The Eastern Corridor

## MEETING #4 NOTES

Dec. 11, 2018

## Eastern Corridor Segments II and III SR 125/SR 32 Focus Area

### Straighten "S" Curve on SR 32

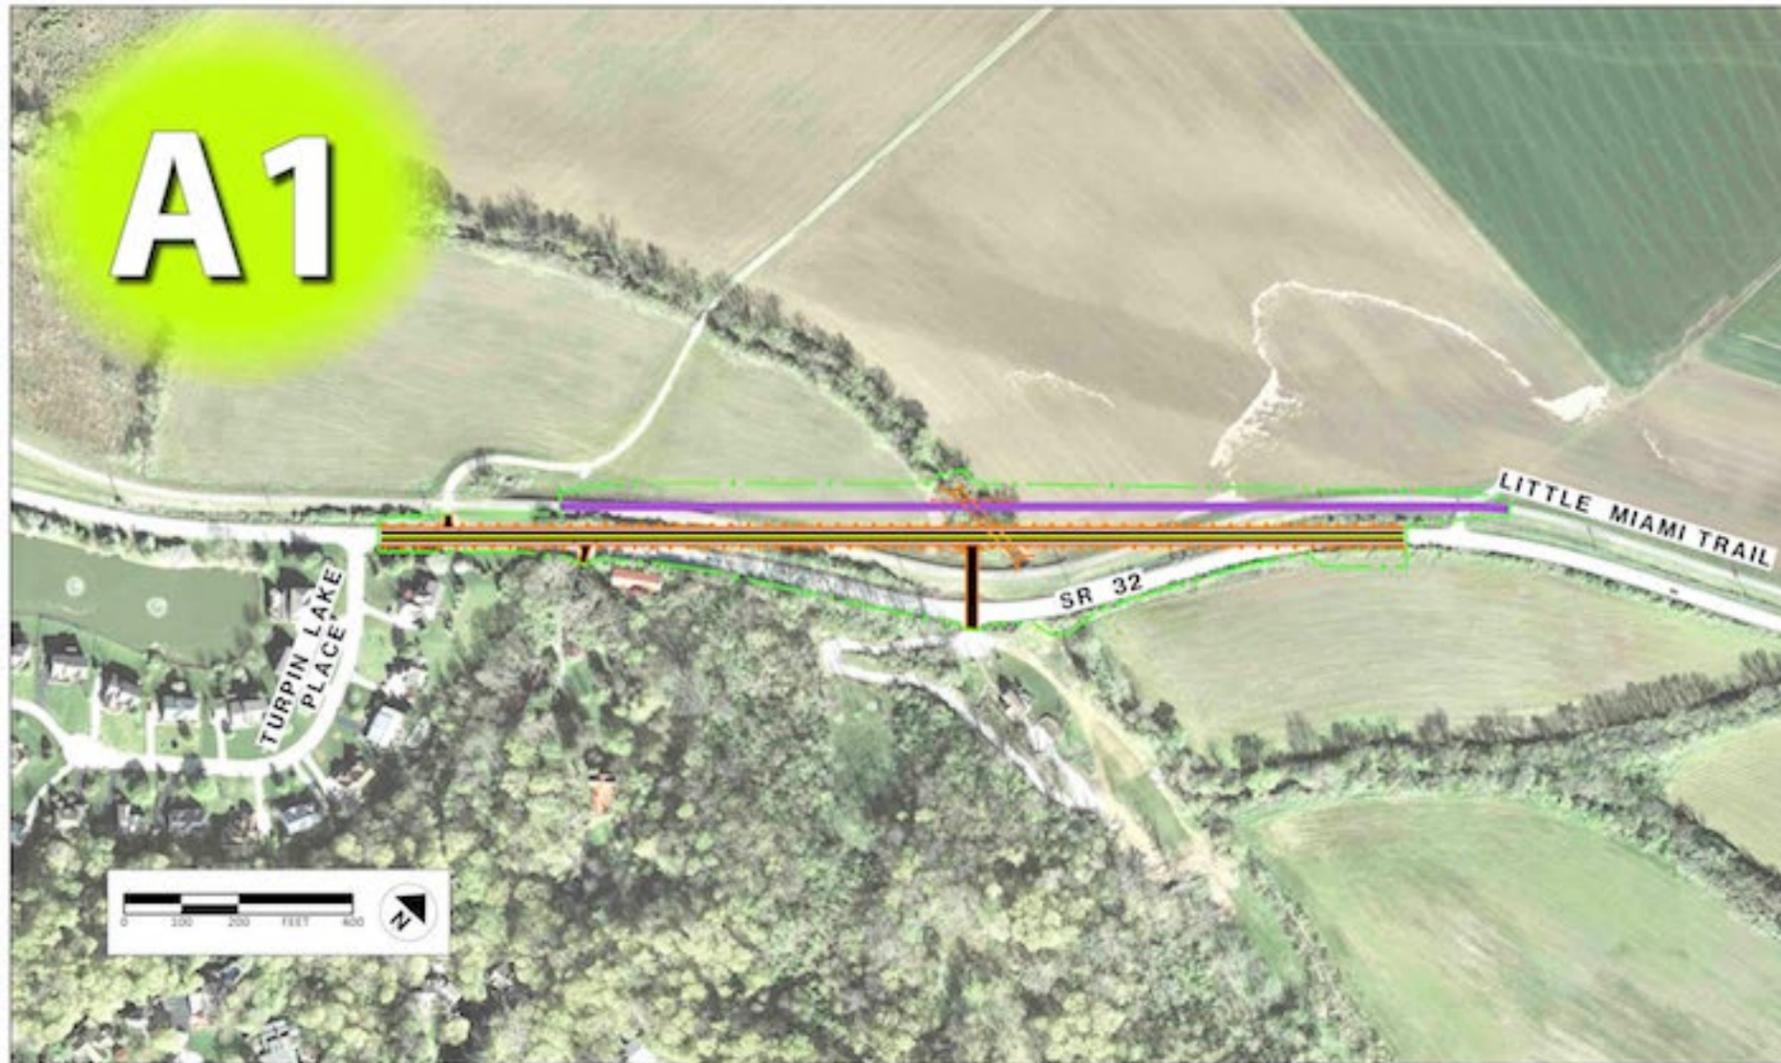
- Public response to this concept tended toward neutral (45%). See Public Feedback Ratings Summary on the next page.
- ODOT noted that as proposed, this concept would address crashes, pedestrian access and flooding issues at this location. However, the committee discussed some concerns regarding the estimated cost of the project.
- Some crashes have occurred in this area, but ODOT has not identified it as an area of particular concern.
- A committee member suggested that costs could be reduced by reducing the speed limit instead of straightening the road. ODOT said a speed study would need to be completed to determine if lowering

- the speed limit is warranted. ODOT also noted that the existing curves of the roadway are designed to accommodate a 45 mph speed limit.
- Anderson Township noted that annual flooding in this area and subsequent access (or lack thereof) is of most concern to them; benefits gained from the project may exceed the cost. The committee briefly discussed focusing more on raising the roadway and less on straightening it.

- The committee noted that even if this project were completed and addressed flooding problems at this location, the project would not address other flooding issues throughout the corridor, therefore flooding would remain a problem unless addressed elsewhere too.

- Another committee member expressed that the “S” curve is not a safety concern, however, the berms (and the risk of driving off of them) are.
- Anderson Township mentioned that it had installed bollards in other places to block access to floodprone areas and they have worked well for the township.

- The estimated project construction cost does not include a pedestrian underpass [the cost for that is included in in concept 32-1b (A8)].

- Include in the Implementation Plan as a low priority.
- Investigate option to raise the road to address flooding without correcting the “S” curve.

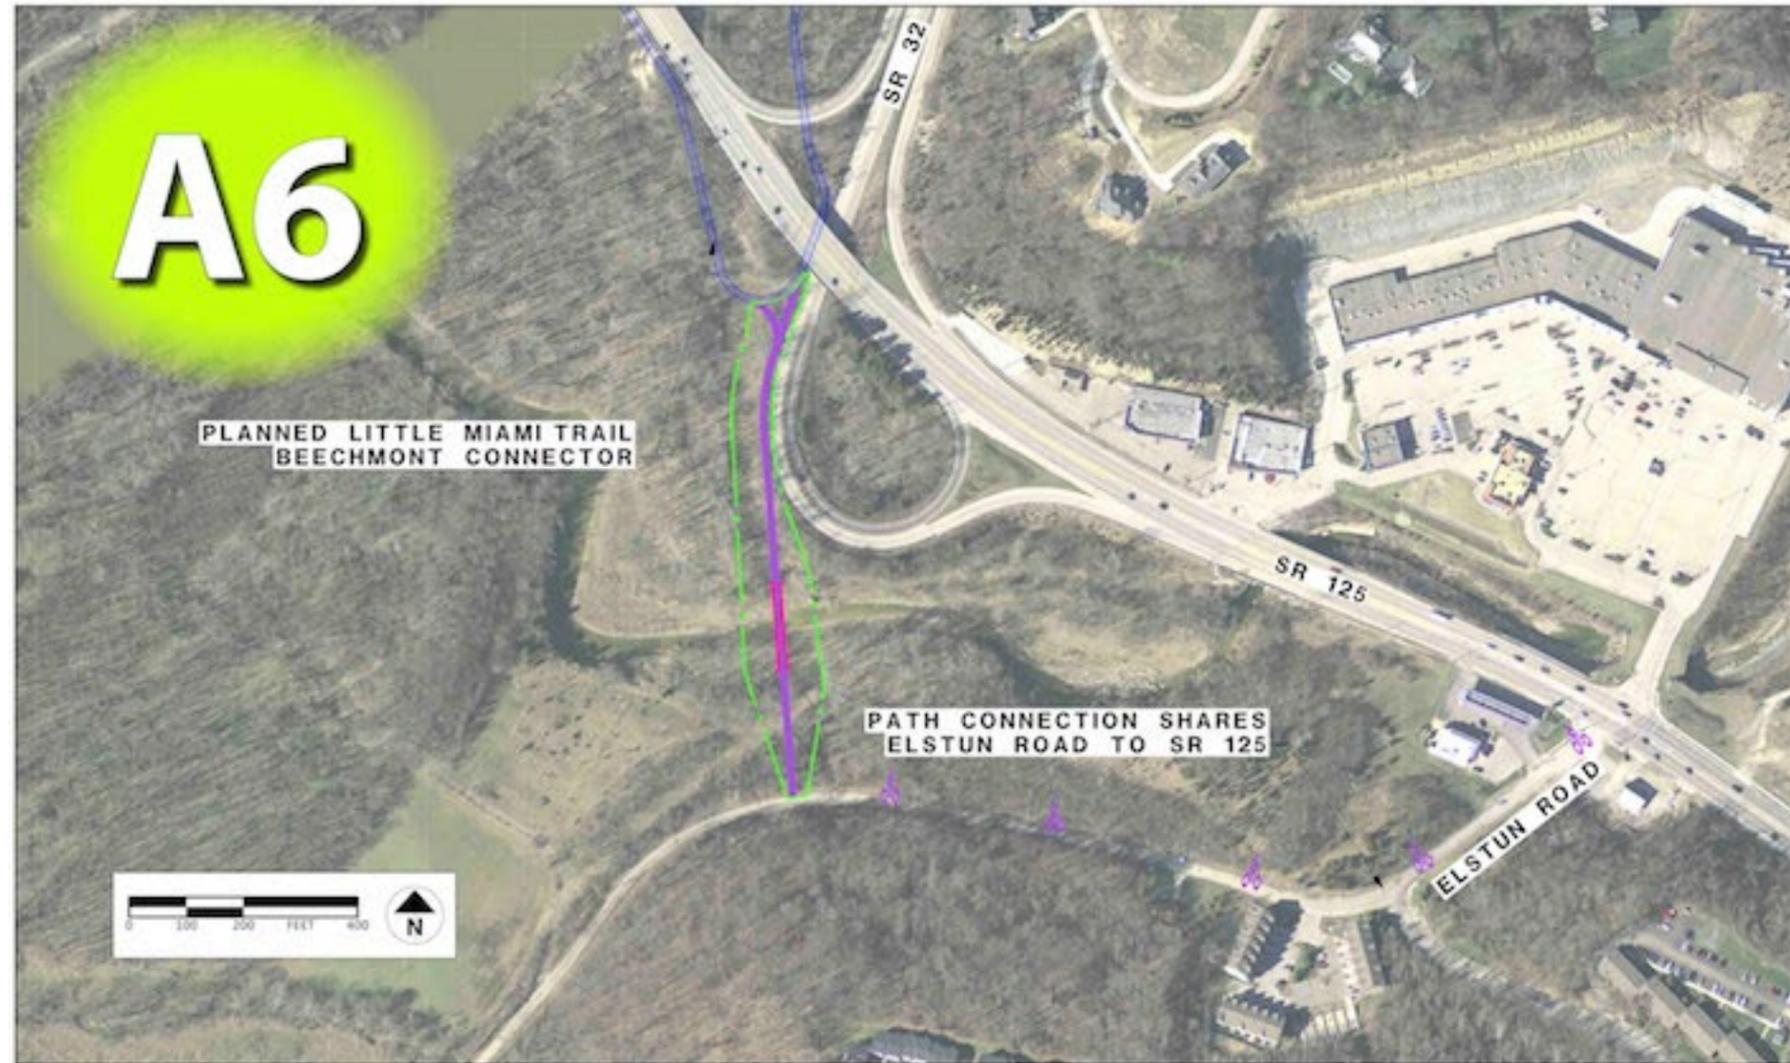
- Anderson Township is currently uncertain as to which option to choose; but wants to make sure that the option chosen offers the most benefit for the investment made.

- There are many buried utilities located on the south side of the ramp which could make construction challenging. Widening the SR 125 bridge over the creek also will be complicated due to buried utilities.

- In concept 125-3 (A5), the path will affect trucks serving UDF.
- In concept 125-3b (A6), it would be preferable to place the path on the south side of Elstun.

- The committee discussed that the estimated cost of concept 125-3b (A6) would increase if the path is extended to SR 125, due to clearing requirements, right-of-way acquisition and the steep hillside. With these costs in mind, the committee proposed eliminating the concept. However, it was determined that more information is needed. Both options will be retained for now.

- The committee noted that the following additional information is needed:
  - Concepts 125-3 (A5): evaluate slope stability
  - Concept 125-3b (A6): evaluate space and hillside issues; update the cost for constructing a shared-use path.

- Include in the Implementation Plan as a high priority.
- Evaluate space and hillside issues further, then add separate shared-use path along Elstun to avoid sharing pavement; update cost estimate.

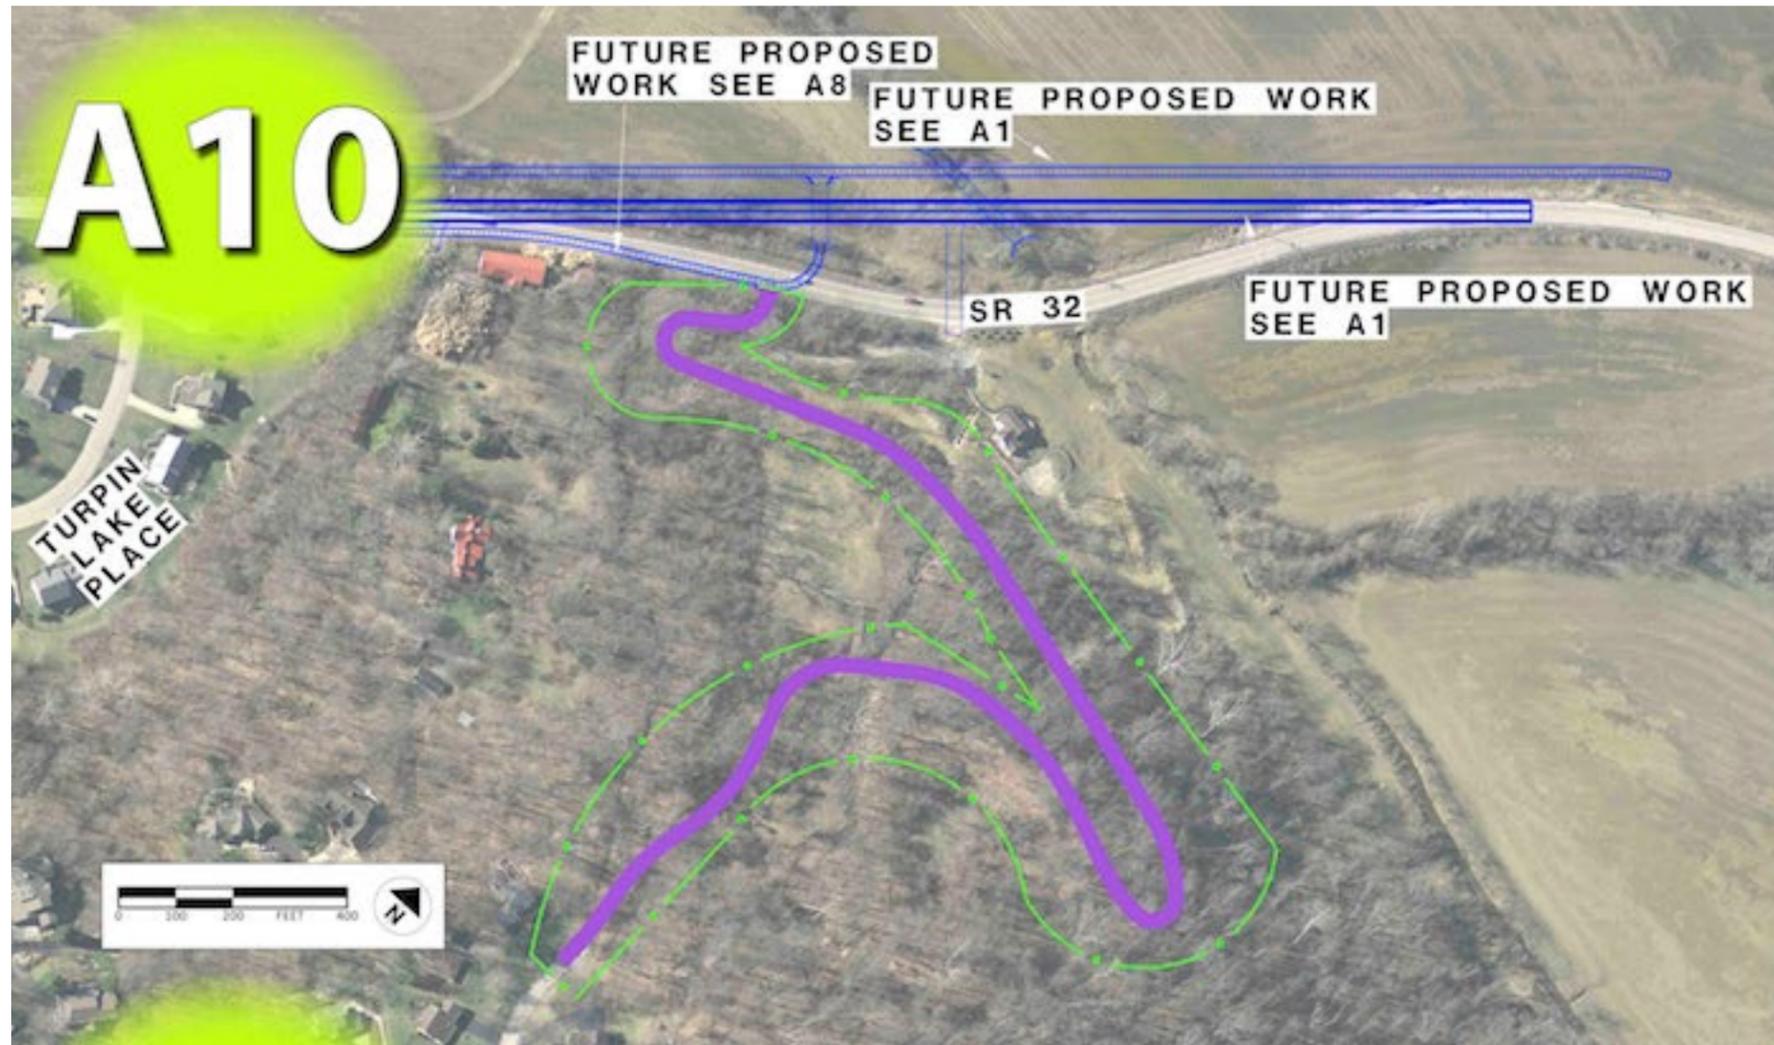
- Ropes Drive is a dead-end. From there, using crushed stone to create a path is a possibility.
- Switching the trail back and forth would help meet ADA accessibility standards by reducing the grade of the path. However, the current design has an 8% grade and the goal would be closer to 5%. If the 8% grade is kept, then the project may not be eligible for federal funding (though Clean Ohio Funds might be an option).

- Include in the Implementation Plan as a low priority.
- Future public involvement efforts will be needed to decide between concepts 32-2a (A9), 32-2b (A10) and 32-3 (A11).
